1997 SEMINAR INFORMATION

"THE RIGHT DIRECTION FOR '97"

AUTOMATIC TRANSMISSION SERVICE GROUP
9200 S. DADELAND BLVD.
SUITE 720
MIAMI, FL 33156
(305) 670-4161

Figure 1

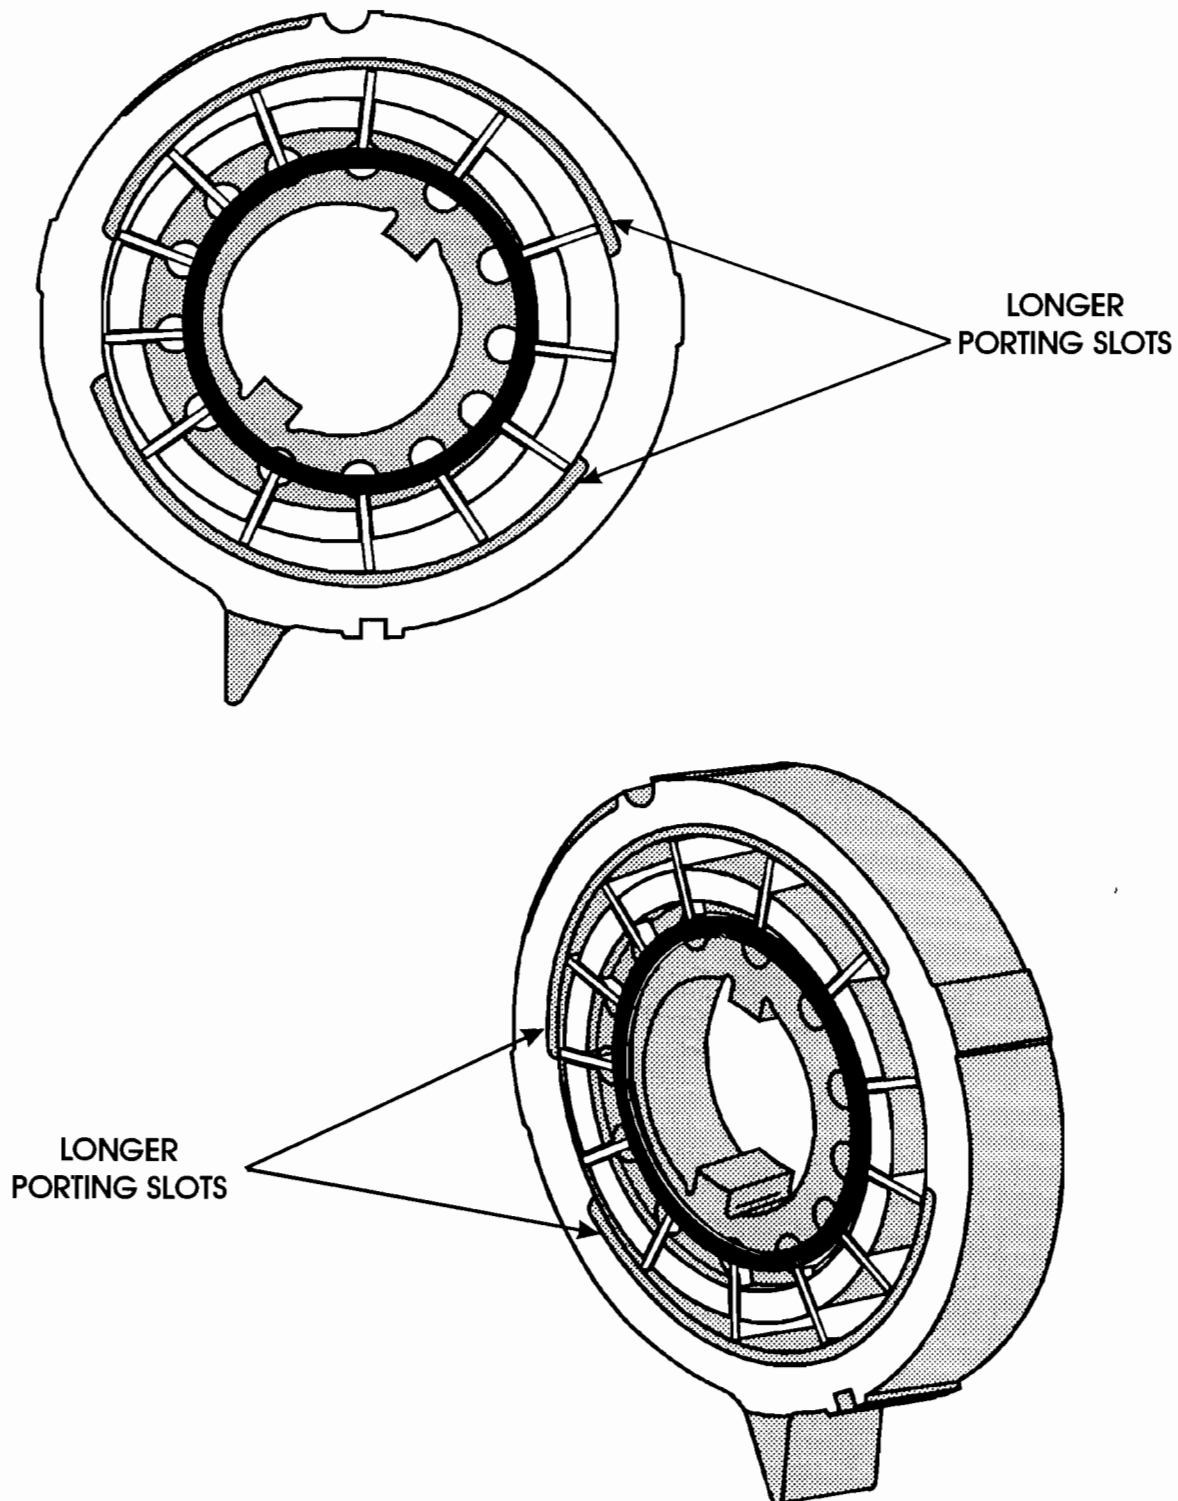
CHANGE: Beginning at the start of production for all 1997 models, there was a new design 13 vane pump rotor and new design pump slide installed in all THM 4L60-E transmissions (See Figure 1).

- (1) OIL PUMP ROTOR - Now has 13 vanes in the pump rotor instead of the previous 10 vanes, as shown in Figure 1.
- (2) OIL PUMP SLIDE - Now has longer porting slots on the face of the slide (See Figure 1).
- (3) ROTOR GUIDE - Now has 13 slots in the rotor guide to accommodate the added vanes.
- (4) OIL PUMP COVER - Now has different configuration on the porting slots in the pump cover to accommodate the changes in the pump slide (See Figure 2). The 13 vane pump cover can be easily identified with "13 V" cast into the back side in the location shown in Figure 3.
- (5) VANE RINGS - Material change to increase vane ring durability.

13 Vane Rotor (17.955mm)	24205400
13 Vane Rotor (17.968mm)	24205401
13 Vane Rotor (17.981mm)	24205402
13 Vane Rotor (17.994mm)	24205403
13 Vane Rotor (18.007mm)	24205404
97 Pump Slide (17.955mm)	24205405
97 Pump Slide (17.968mm)	24205406
97 Pump Slide (17.981mm)	24205407
97 Pump Slide (17.994mm)	24205408
97 Pump Slide (18.007mm)	24205409
Plastic Rotor Guide (13 Vane)	24205410
Oil Pump Vanes (13 Required)	8631280
Pump Vane Rings (13 Vane)	24201144

Figure 3

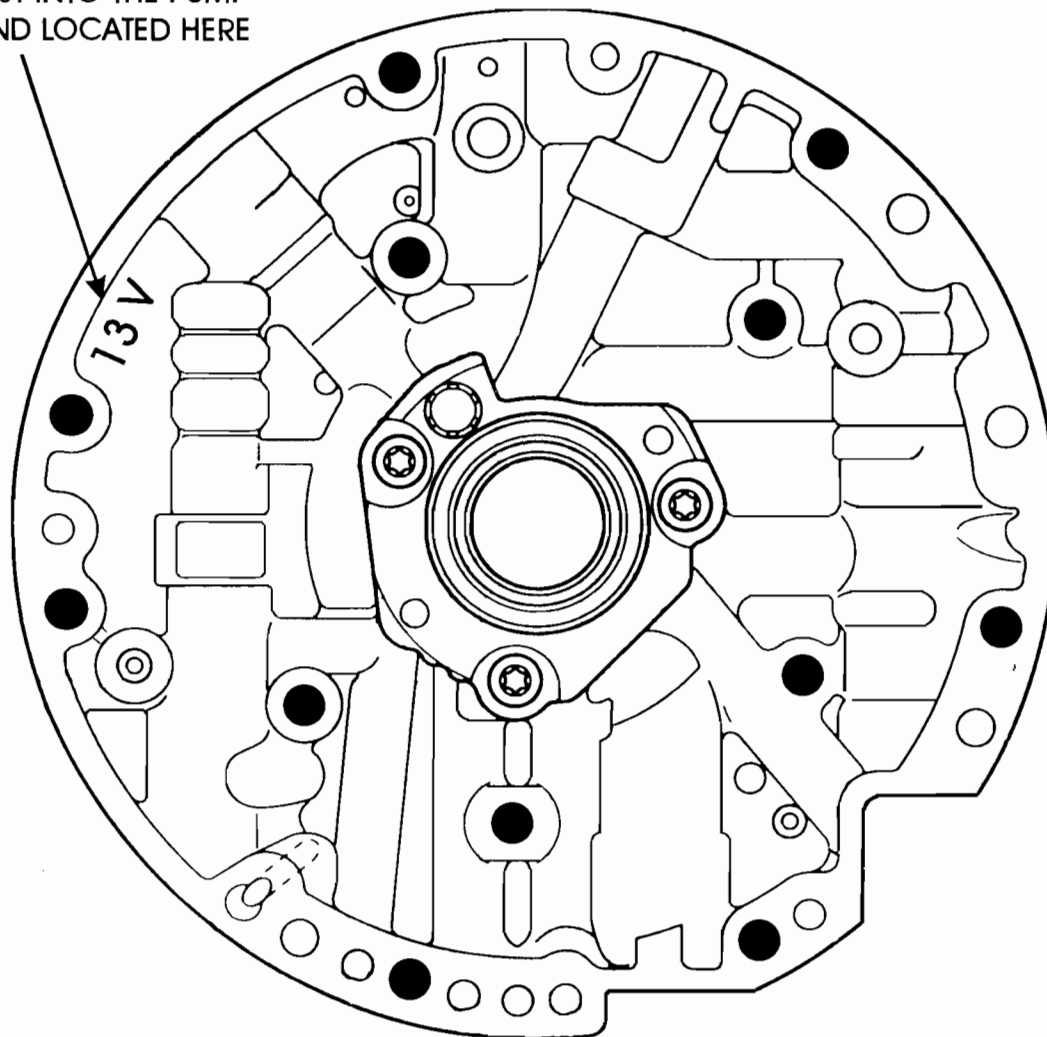
"13 V" CAST INTO THE PUMP
COVER AND LOCATED HERE

***THIS PUMP COVER WILL NOT INTERCHANGE WITH PREVIOUS MODELS.
IT MUST BE USED WITH THE 13 VANE ROTOR AND SLIDE.***

Figure 7

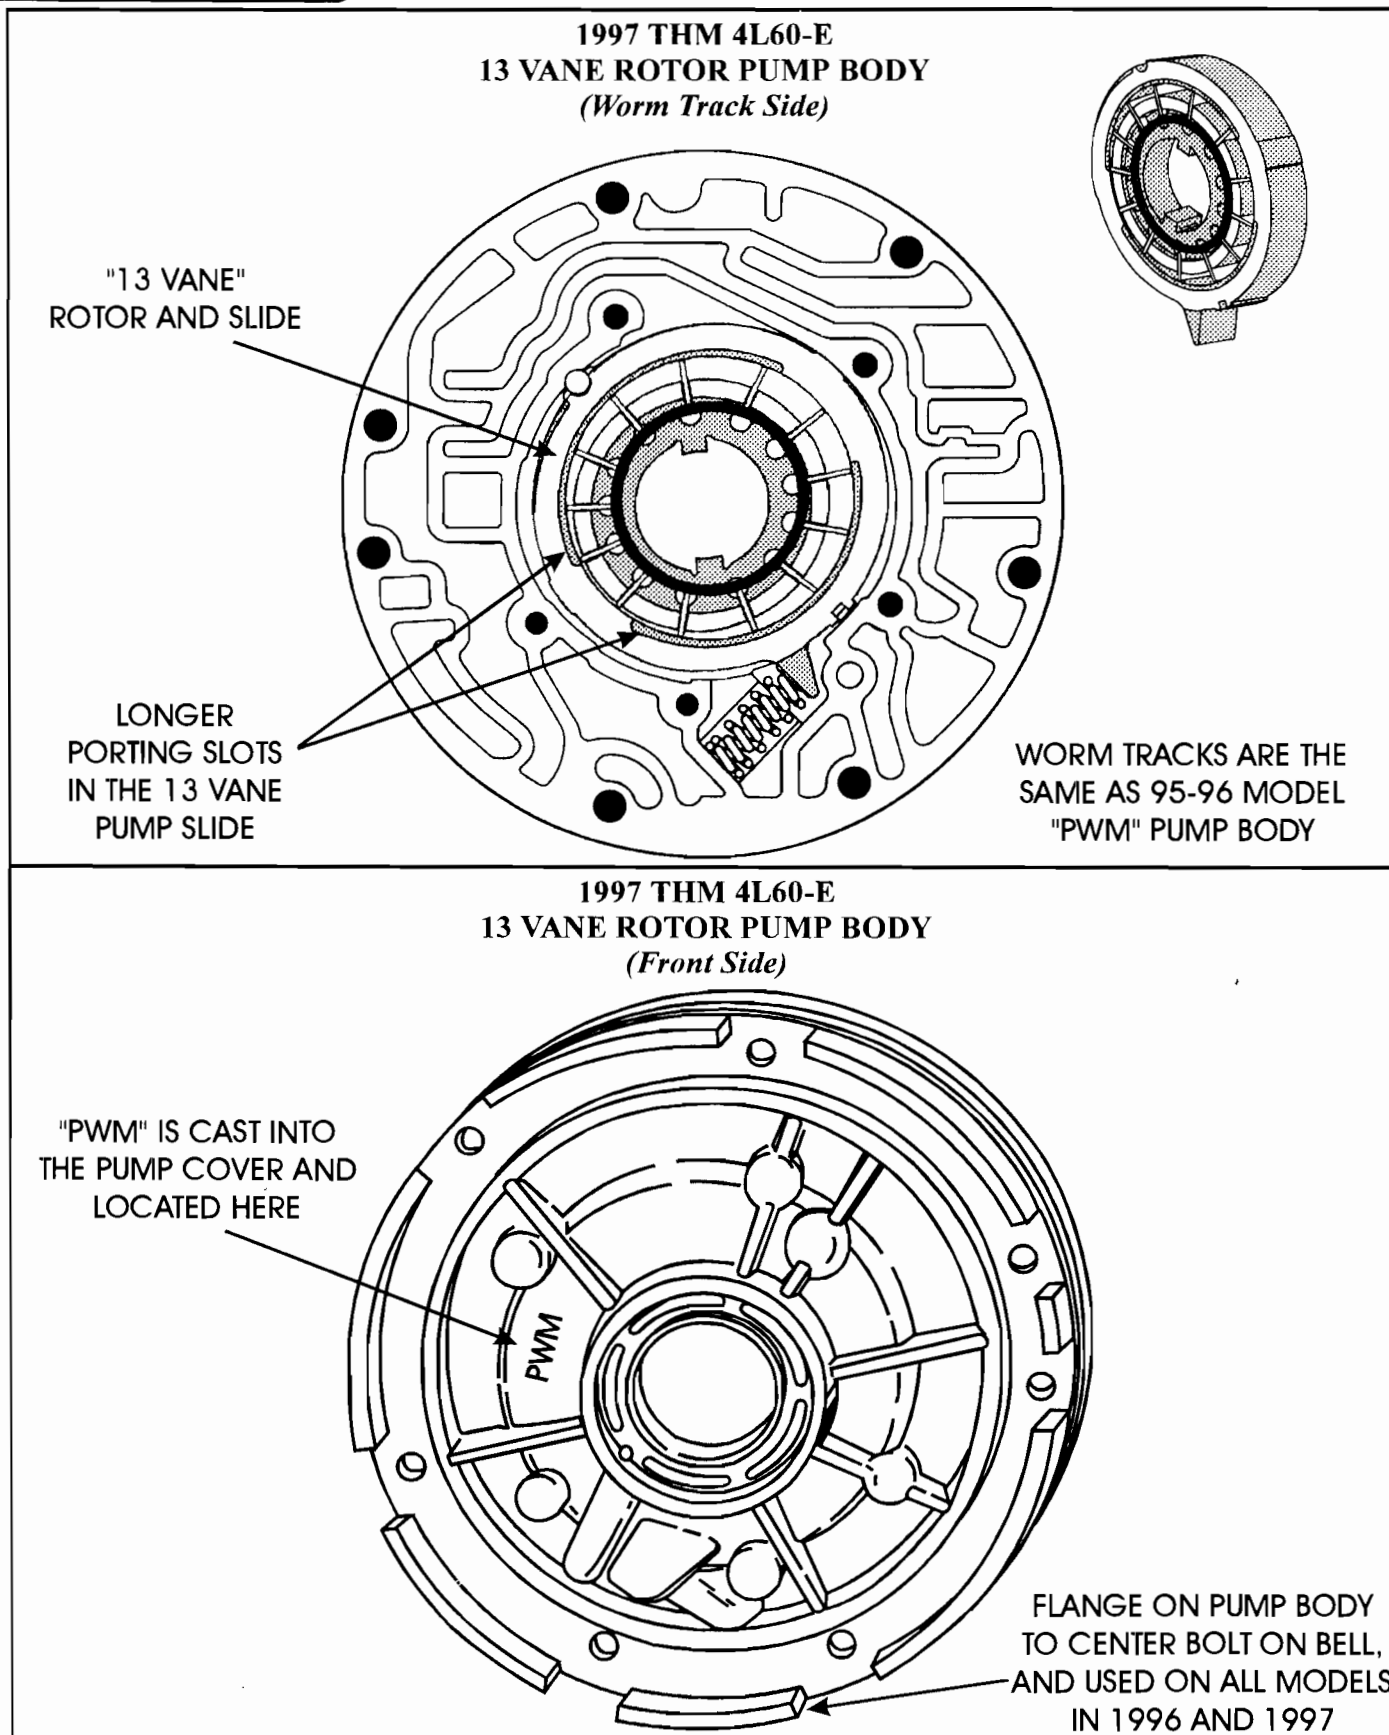
Pump Body - Has the same worm track configuration as the 95-96 "PWM" Pump Body, but a 13 Vane rotor and slide assembly was introduced, as shown in Figure 7. The 13 Vane slide has longer "Porting Slots" as shown in Figure 7. The "PWM" is still cast into the front side of the Pump Body. Refer to Figure 7.

Figure 1

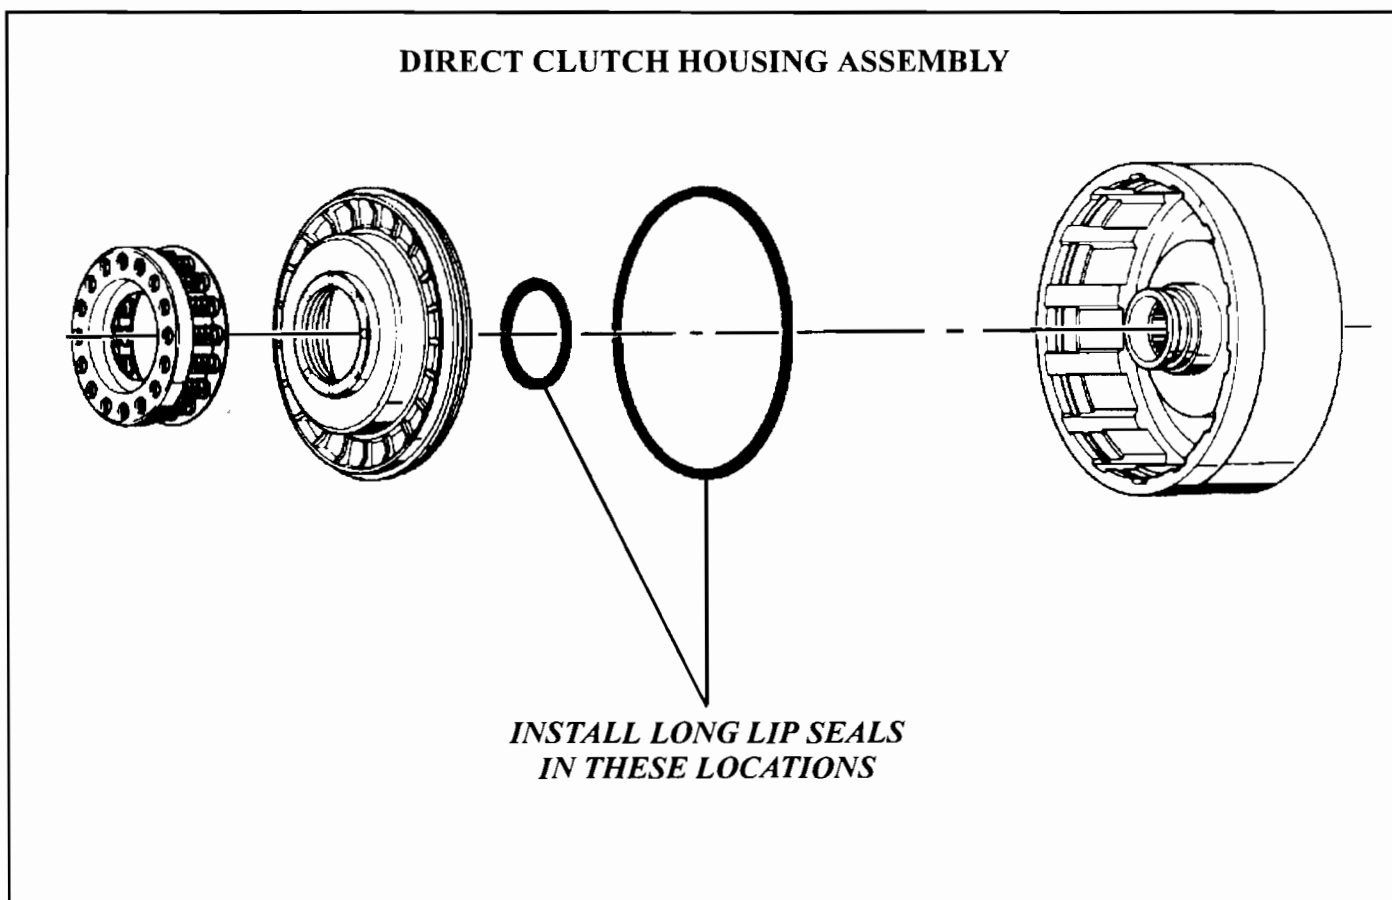
CAUSE: The cause has been traced to the use of short lip seals on the direct clutch piston, causing the direct clutch not to apply when reverse is selected.

CORRECTION: Install **LONG** lip seals on the direct clutch piston when reconditioning the transmission, as shown in Figure 1. Also be sure to replace the solid Teflon sealing rings on the center support with **White or Tan rings with Red and/or Green speckles** (See Figure 2). Always replace the center support feed bolt with a **new** one every time it is removed, and ensure that the center support is **Fully** drawn up against the case surface (See Figure 3).
Special Note: The new center support bolt allows one time reuse/reassembly of the center support by achieving the same level of thread interference as the production assembly. Torque for the service bolt is 37 ft.lbs., and the run-in torque will be about half of this value.

Figure 1

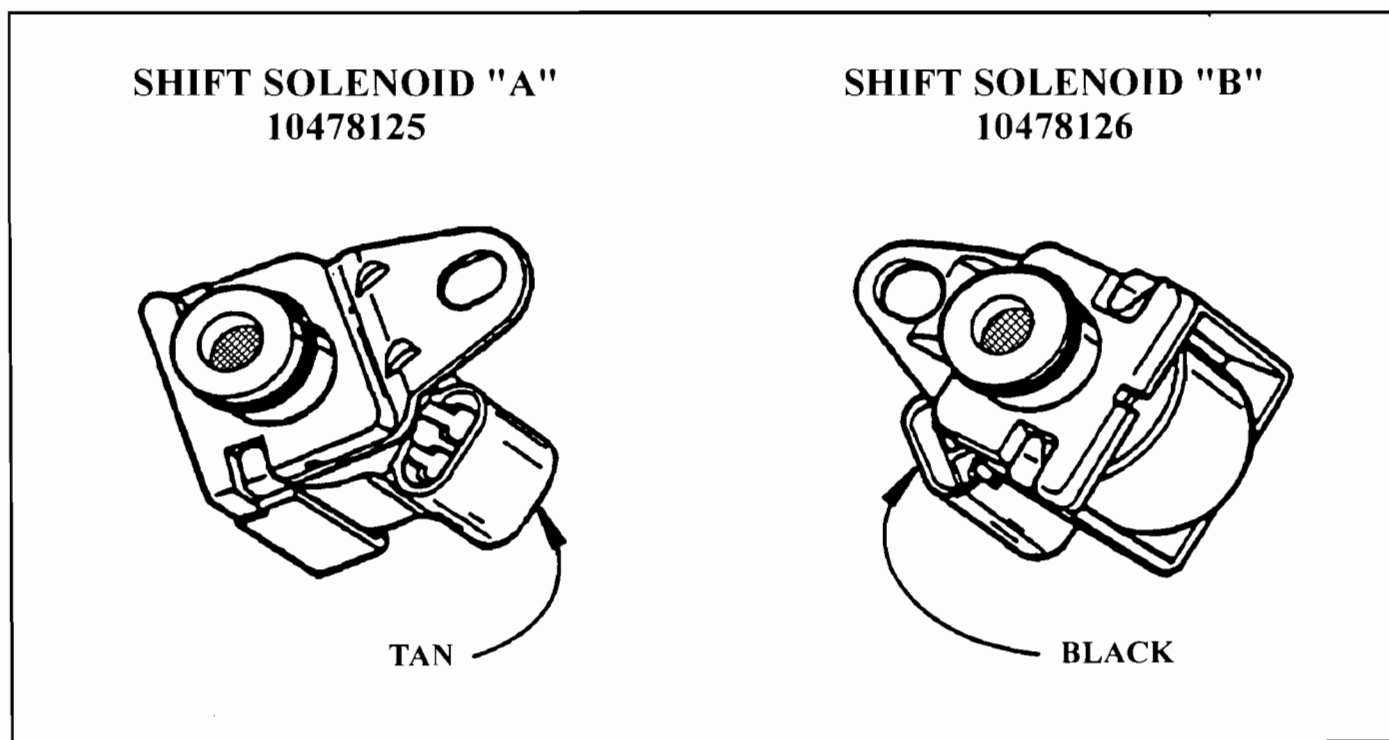
CHANGE: Beginning in the middle of 1996 model year, as a running change, all THM 4L80-E/4L80-EHD transmissions were built with revised shift solenoids once again.

REASON: Revised internal seal material and coil windings for increased durability.

- (1) SHIFT SOLENOID "A" - Revised internal seal material, and is now TAN in color, instead of the previous Purple (See Figure 1).
- (2) SHIFT SOLENOID "B" - Reveised internal seal material, and is now BLACK in color, instead of the previous Tan (See Figure 1).

Shift Solenoid "A" (TAN)	10478125
Shift Solenoid "B" (BLACK)	10478126

Figure 1

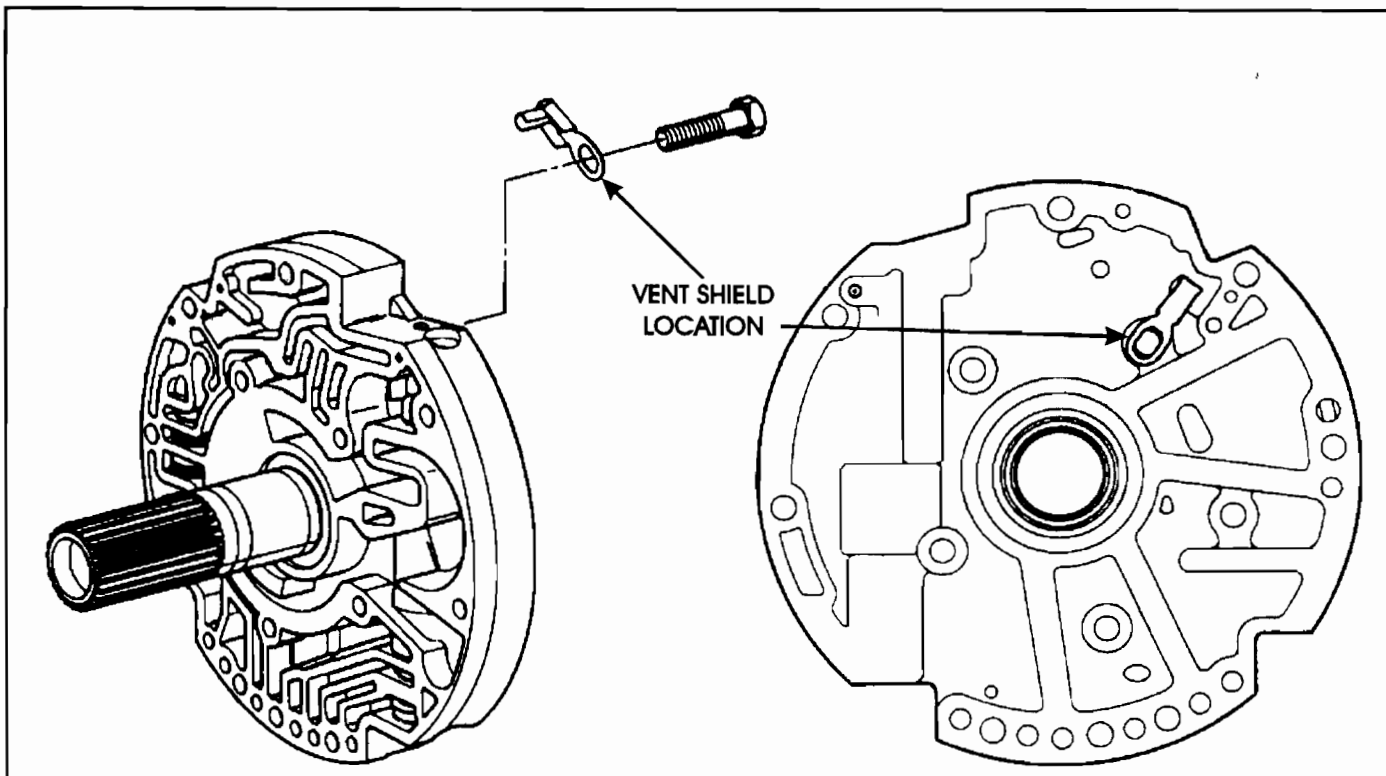
CHANGE: Beginning at start of production for all 1994 model THM 4L80-E/4L80-EHD transmissions, there was a Vent Shield added to the back side of the pump cover, and retained by a pump cover to pump body retaining bolt as shown in Figure 1.

(1) VENT SHIELD - Added to the oil pump assembly in model year 1994 (See Figure 1).

Vent Shield, Oil Pump 24200357

Figure 1

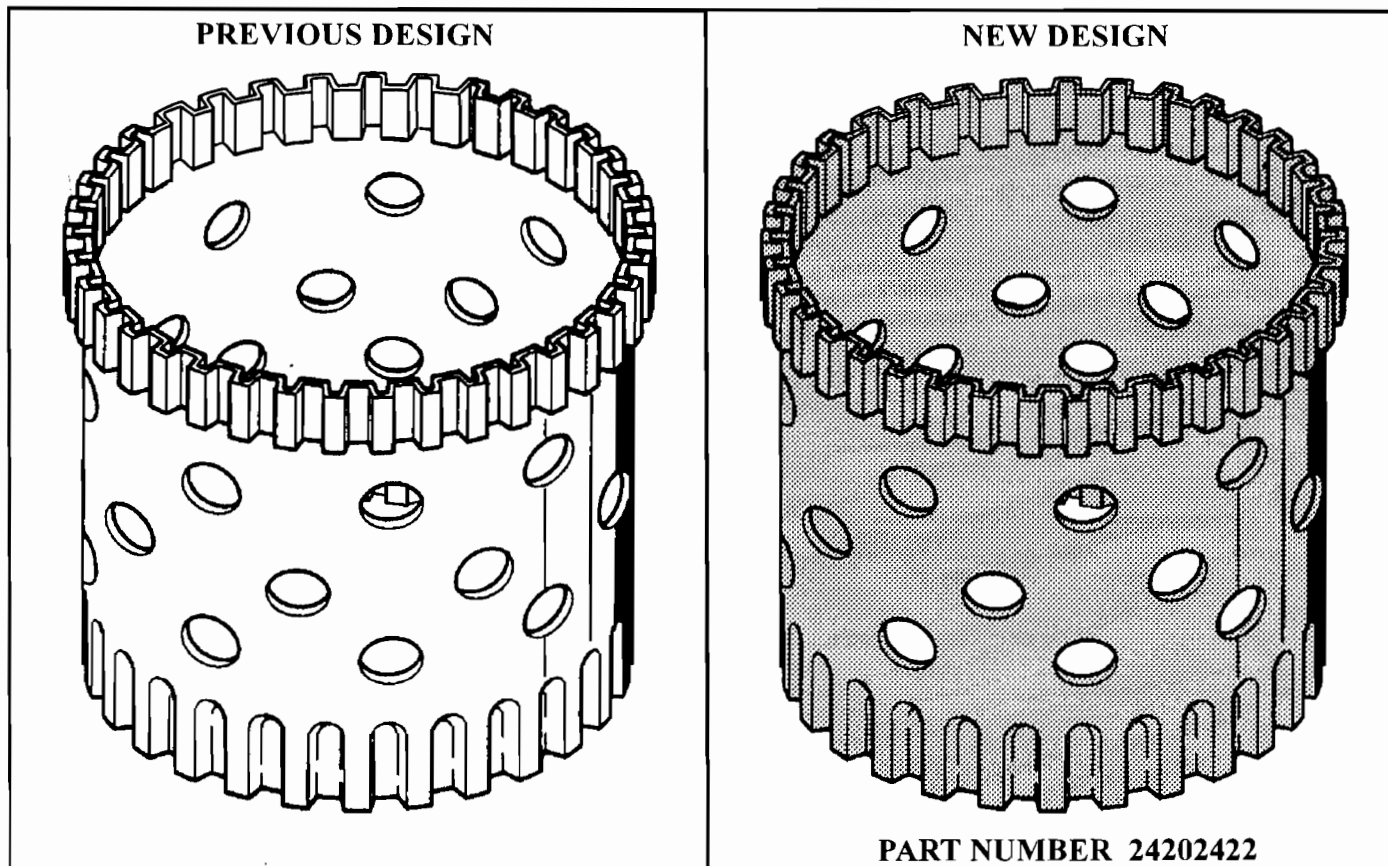
CHANGE: Beginning at the start of Production for 1997 models, all THM 4T60-E transaxles were built with a new design Reverse Reaction Drum, as shown in Figure 1.

- (1) REVERSE REACTION DRUM - New design has been through a hardening process and can be identified by its blackened color, as shown in Figure 1.

Reverse Reaction Drum (New Hardened Design) 24202422
